REMARKS

This Supplemental Response addresses the issues set forth in the Office Action dated March 16, 2004, as well as issues set forth in the Advisory Action dated September 28, 2004. Applicants are especially grateful for the careful consideration that Examiner Ciric has given to this application and for the helpful suggestions made for improving the application text and claims. The Examiner apparently appreciates the challenges in defining the present invention, which involves the somewhat unusual situation involving selectively and alternatively attachable parts. Applicants appreciate the helpful and cooperative spirit in which this application has been considered.

Amendments to the Drawings:

Fig. 1

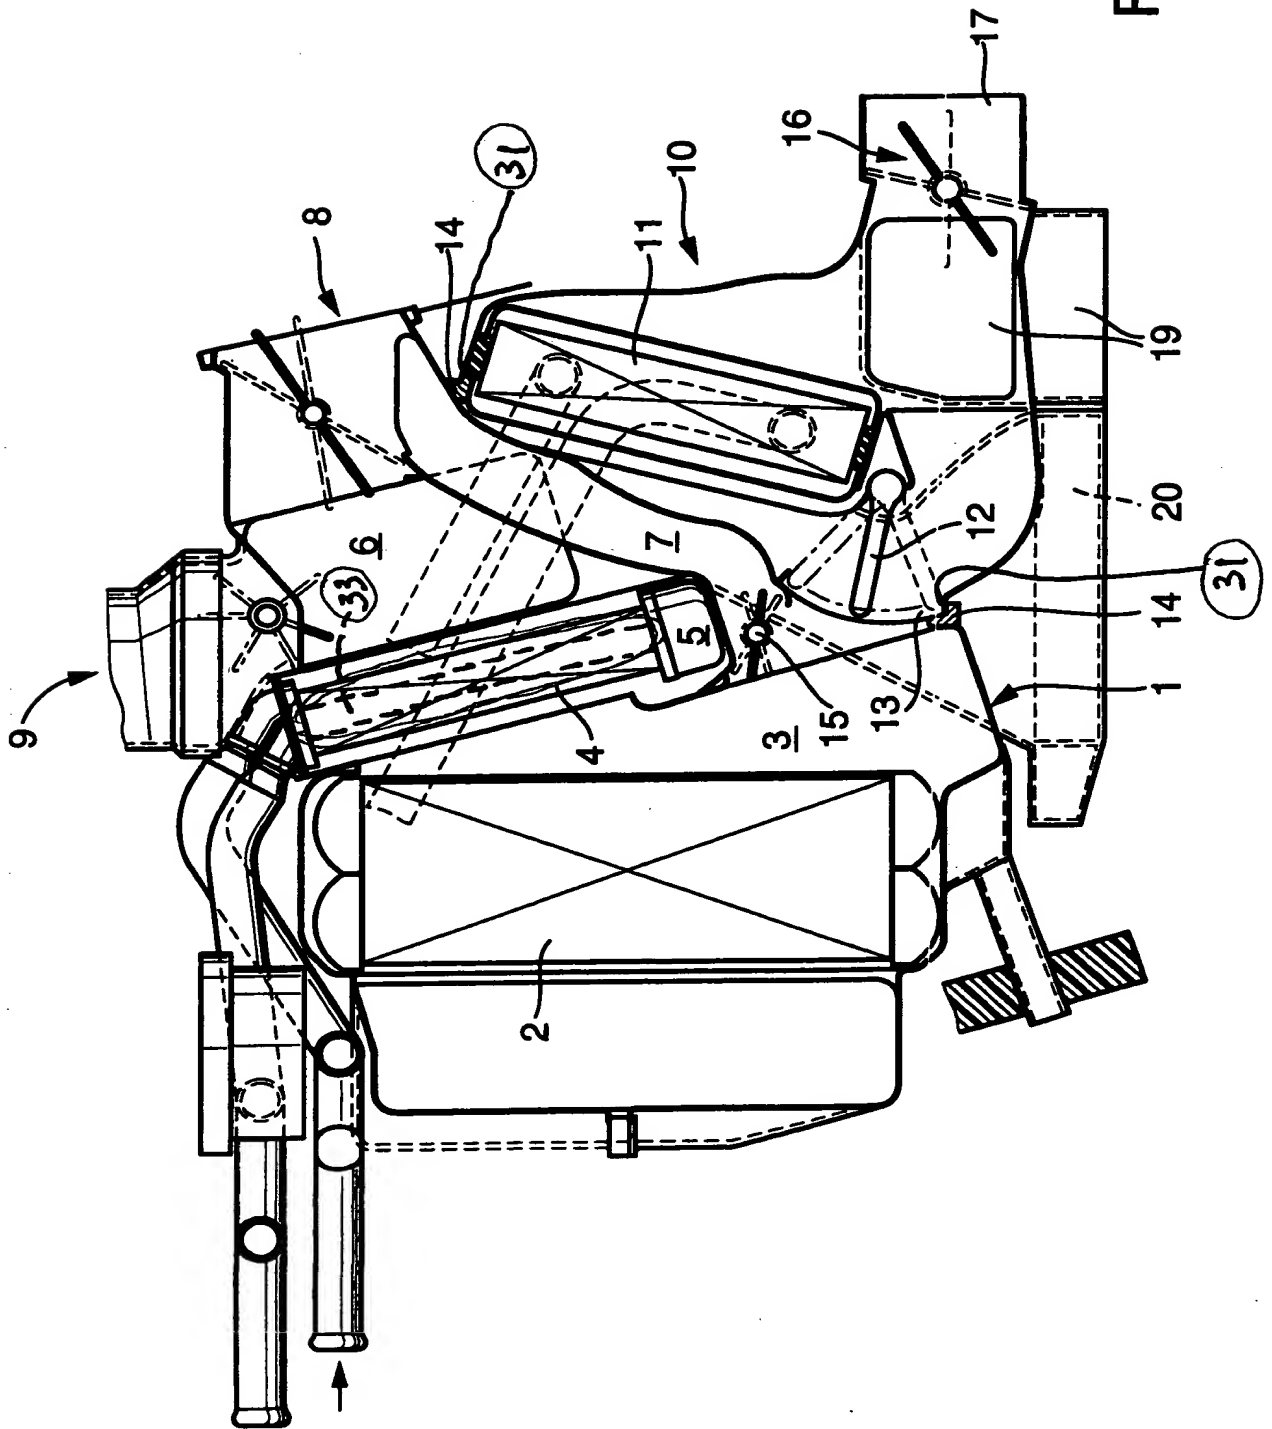
As noted above, Figures 1, 2 and 4 have been amended to identify more clearly the corresponding portions of the connection section and of the respective cover 18 and additional housing 10 of the rear temperature control unit. Similarly, Figure 1 now depicts the PTC units in heater 4. Approval of these proposed changes is respectfully requested.

With regard to claim 14 (new claim 30), Applicants submit that the use of PTC elements in automotive heaters is well understood by persons skilled in the art, as these are very conventional (as noted in paragraph 25 of the Office Action). Since the PTC elements are now depicted schematically in the drawings, it is believed that the concerns of the PTO are satisfied.

The drawing sheets attached in connection with the above-identified application contain Figures 1-4 are being presented as corrected drawing sheets to be substituted for the previously submitted drawing sheets. Also attached is a replacement formal drawing sheet for Figure 7, which was approved in the Office Action. Drawing Figures 1, 2 and 4 have been amended. The specific changes which have been made to Figure 1 are a schematic depiction of a PTC heating element and reference numerals 31 referring to the portions of the connecting structure formed on the additional housing 10 that serve as part of means for connecting that housing to the connecting section of the conditioning housing 1. The change to Figure 2 is the addition of new reference numeral 29 to refer to the portion of the connecting structure that is part of cover 18 and cooperates with flanges 14 of the connecting section. The change to Figure 4 is the addition of reference numeral 31, similar to Figure 1. Corresponding additions have been made to the specification, above.
